SLIM CHICKENS SITE PLAN

TOWN OF PARKER PLAN REVIEW

SITE PLAN
SLIM CHICKENS
COVER SHEET
SVC OF S. PARKER ROAD AND E. PINE LANE, PARKER, CO 80134

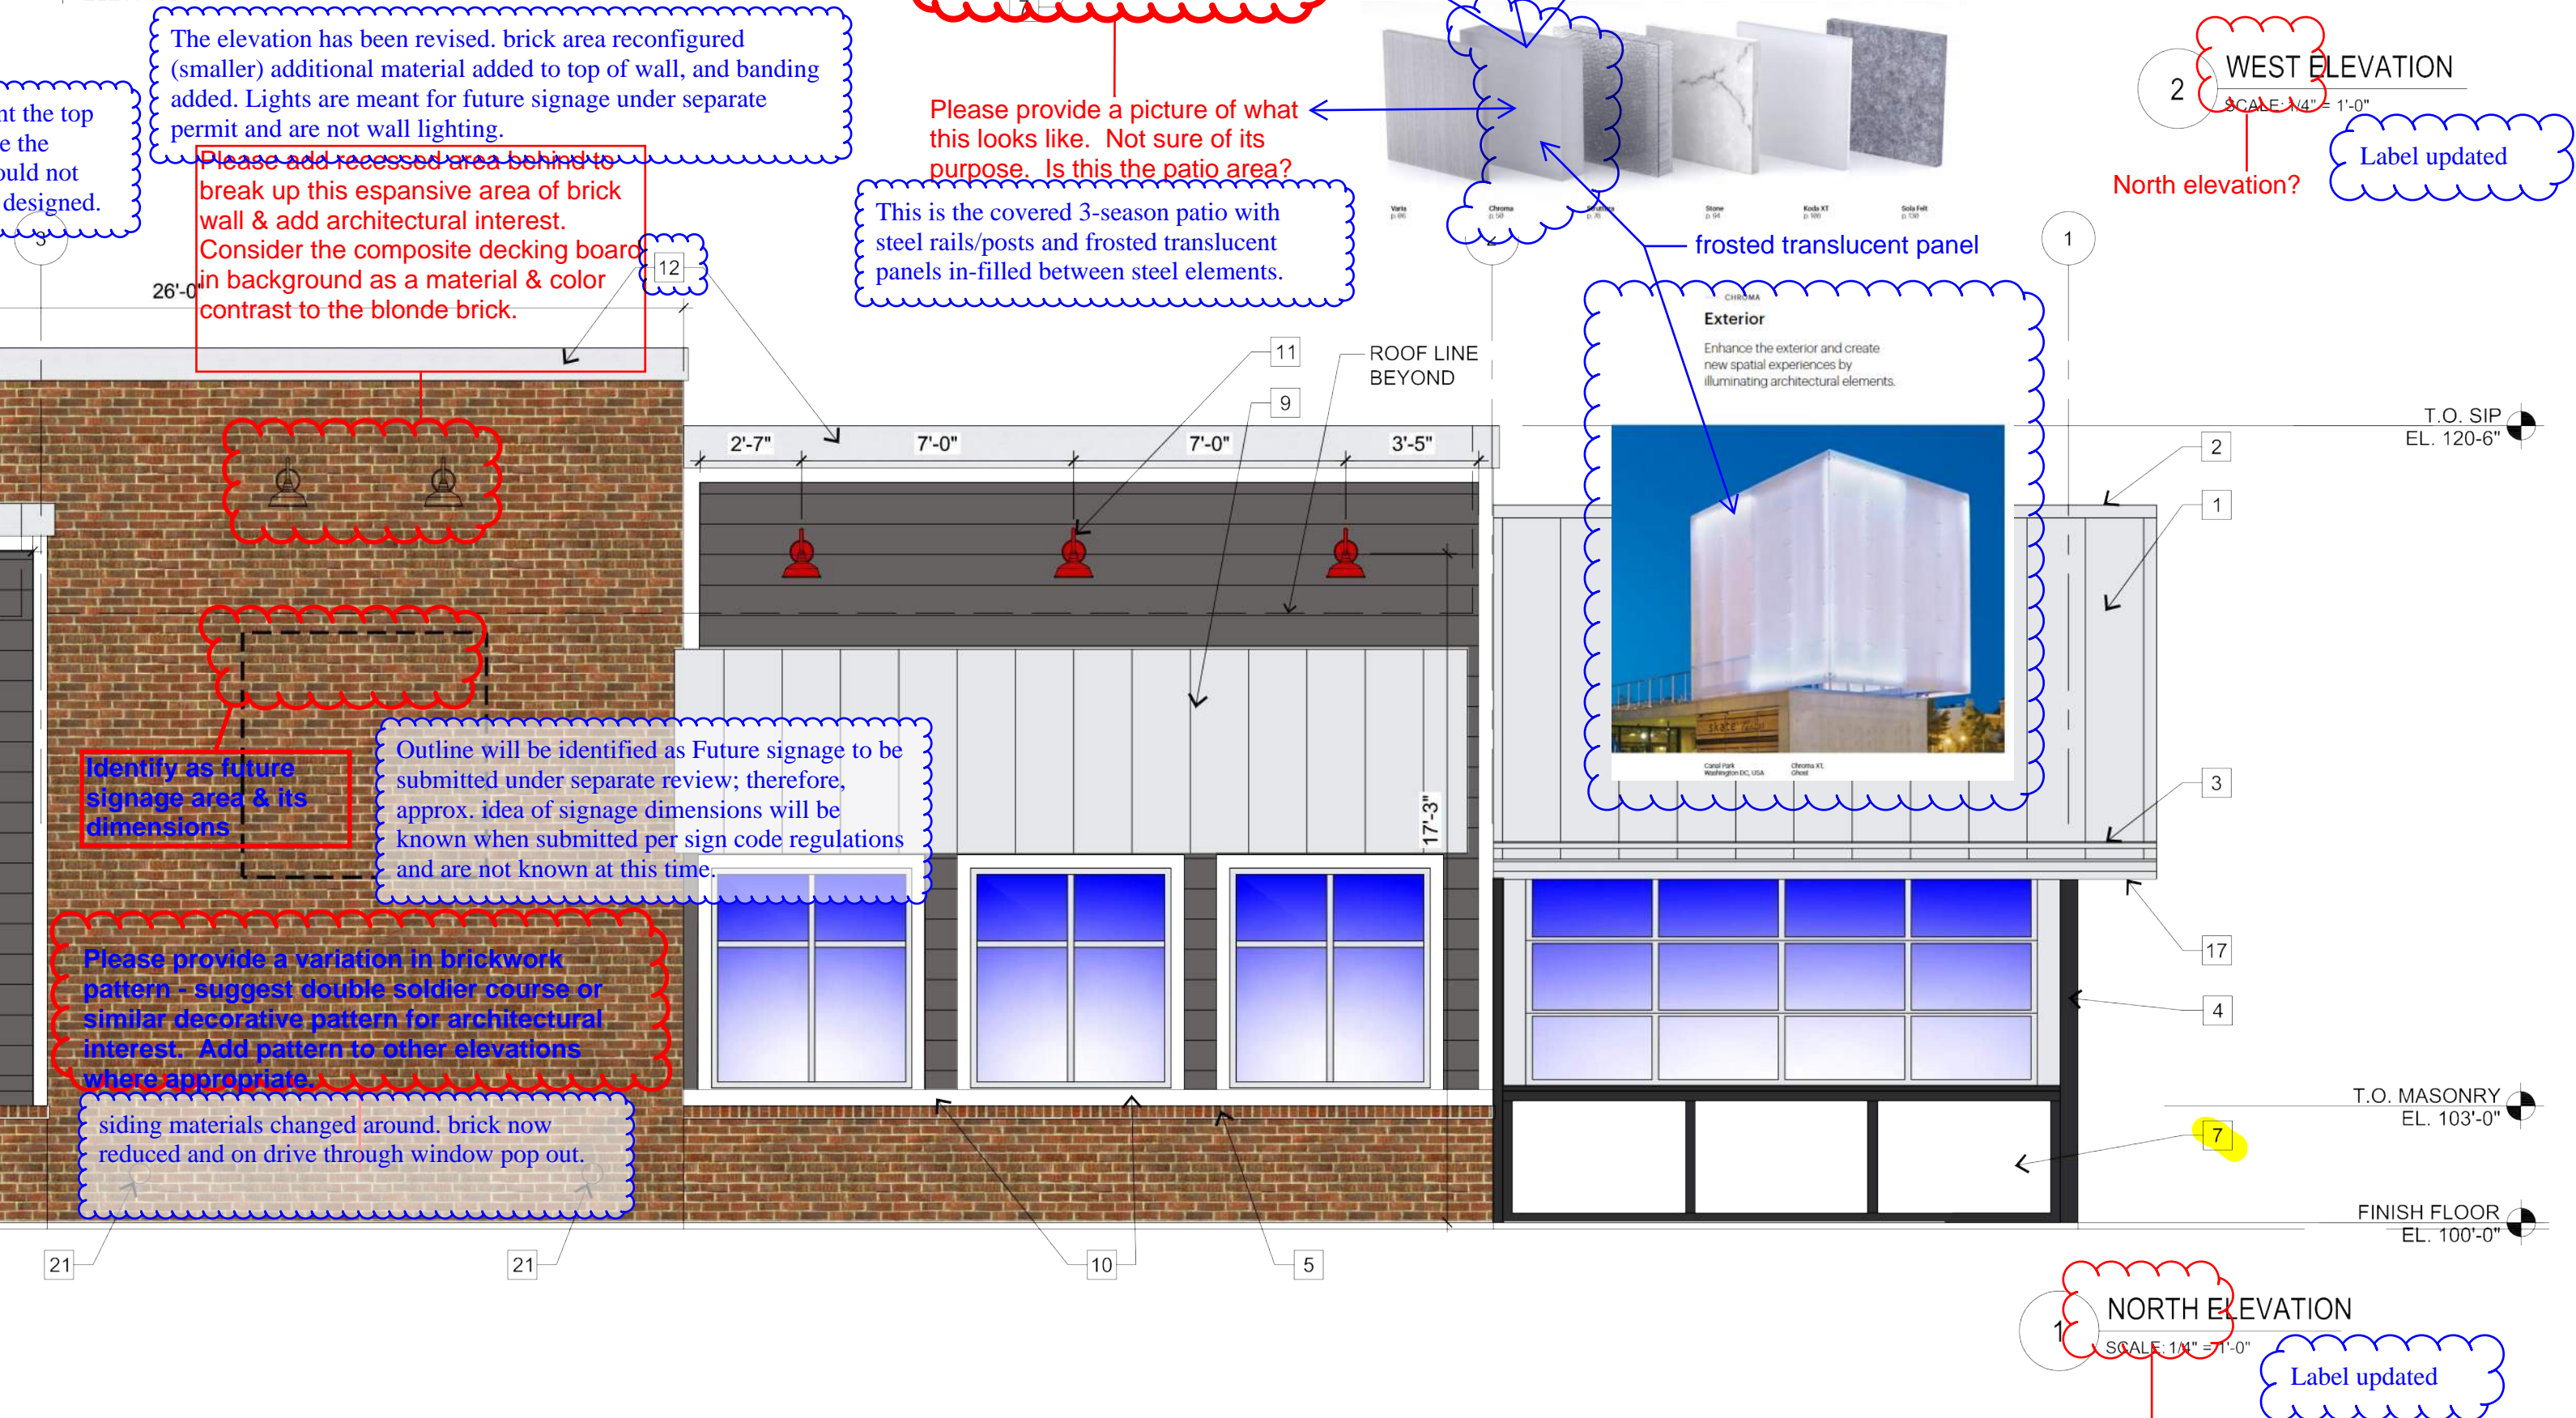
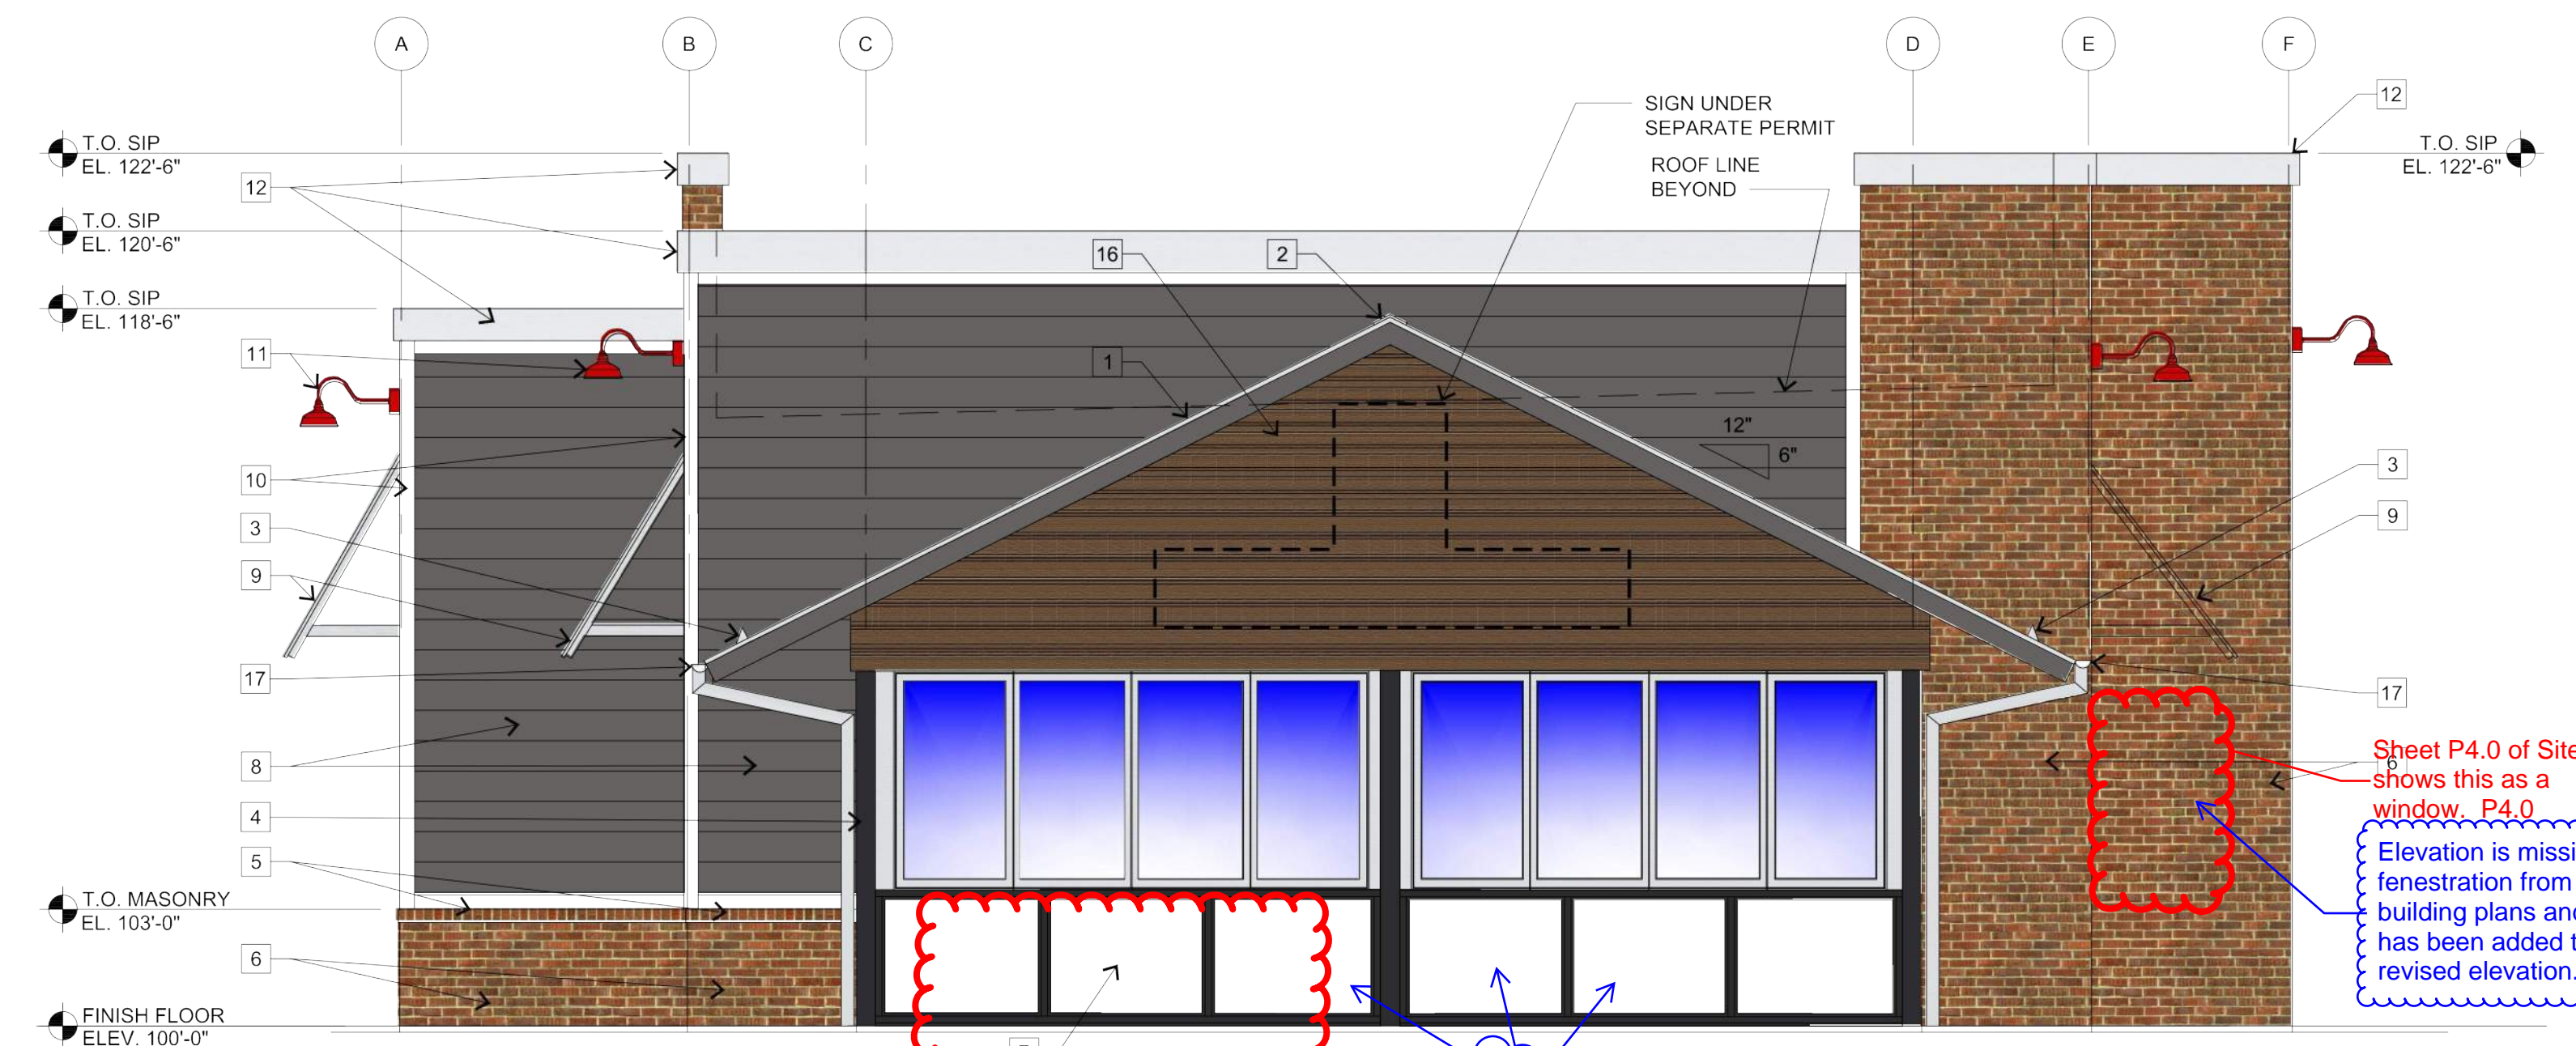
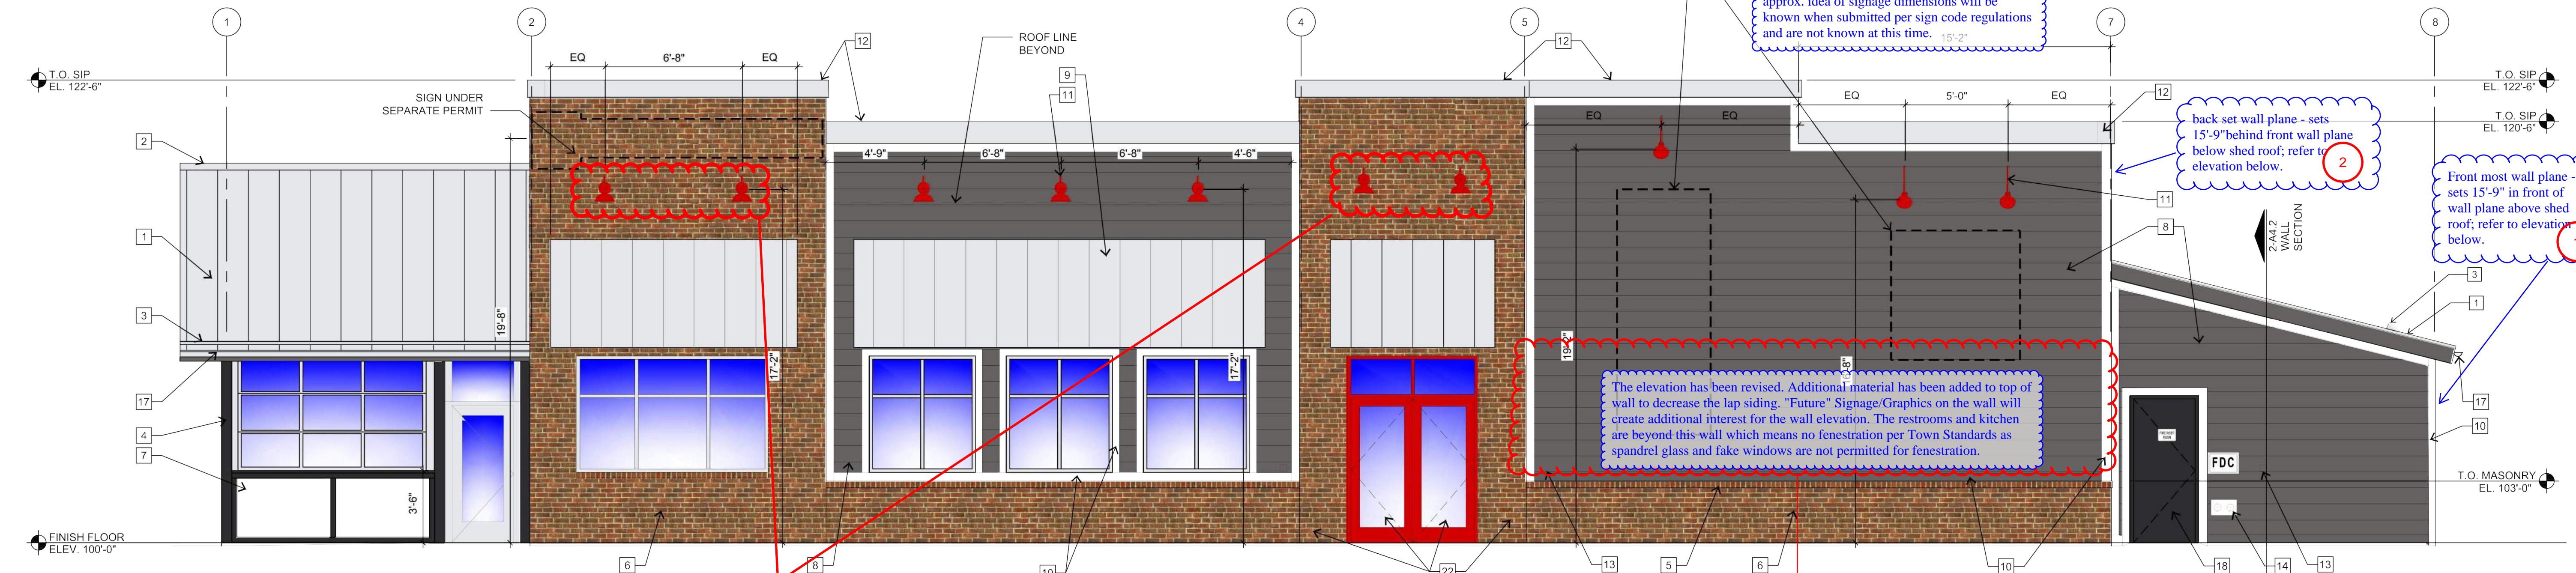
Large blank area. Please add additional articulation and/or fenestration for architectural interest - especially since this is on a highly visible roadway.
 The elevation has been revised. Additional material has been added to top of wall to decrease the area of lap siding. IREA panel size more accurately shown reducing amount of visible lap siding.

Should lights be offset to side since they'll be shining down on awning?

Identify signage dimensions

The elevation has been revised. Additional material has been added to top of wall to decrease the amount of lap siding. "Future" Signage/Graphics on the wall will create additional interest for the wall elevation. The kitchen is beyond this wall which means no fenestration per Town Standards as spandrel glass and fake windows are not permitted for fenestration.

Town of Parker Standards Note removed from sheet.

Note updated to require Town Approval if changed prior to construction.
